QUALITY ASSURANCE -- NON-CONFORMANCE REPORT

Location: Changxing Island, Shanghai, P.R. China **Report No:** NCR-000575
Prime Contractor: American Bridge/Fluor Enterprises, a JV **Date:** 01-Jan-2010
Submitting Contractor: Zhenhua Port Machinery Company, Ltd (ZPMC), Changxing Island **NCR #:** ZPMC-0548

Reference Description: Base Metal Repair without Engineer's Approval, East Shaft, Lift 1, Skin A Stiffener

Job Name: SAS Superstructure
Document No: 05.03.06-000538

Reference Description: Base Metal Repair without Engineer's Approval, East Shaft, Lift 1, Skin A Stiffener

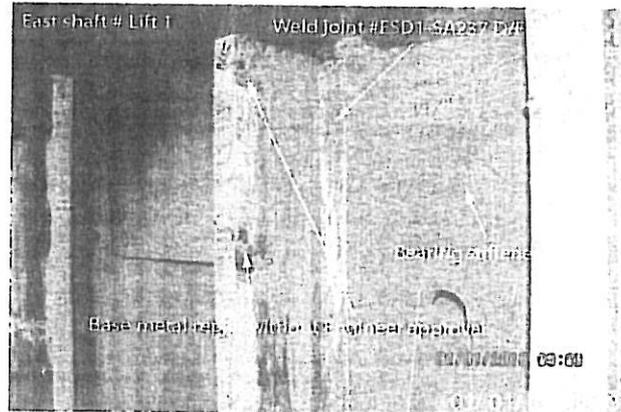
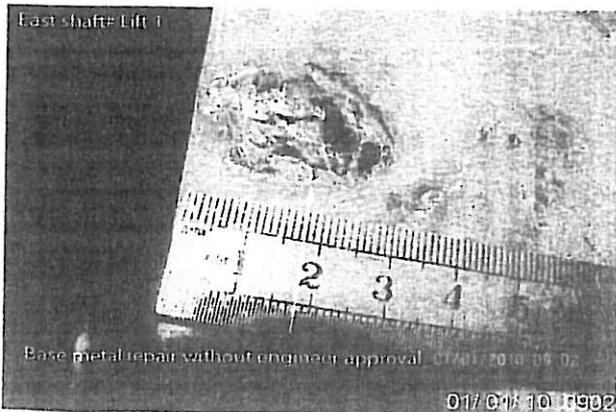
During Quality Assurance (QA) random verification visual inspection at the heavy dock jetty, this QA Inspector discovered the following issue:

- Base metal repairs of Skin A stiffener without the Engineer's approval.
- The length of the base metal repairs were approximately 15mm and 25mm in length.
- The member is identified as Skin A stiffener, inside East Shaft – Lift 1.
- The member is located at the heavy dock jetty outside.
- The nearby weld joint is identified as: ESD1-SA 237 D/F-4
- The repair was performed utilizing the Shielded Metal Arc Welding (SMAW) process.
- The material is classified as A709 Grade 345 (Non SPCM).
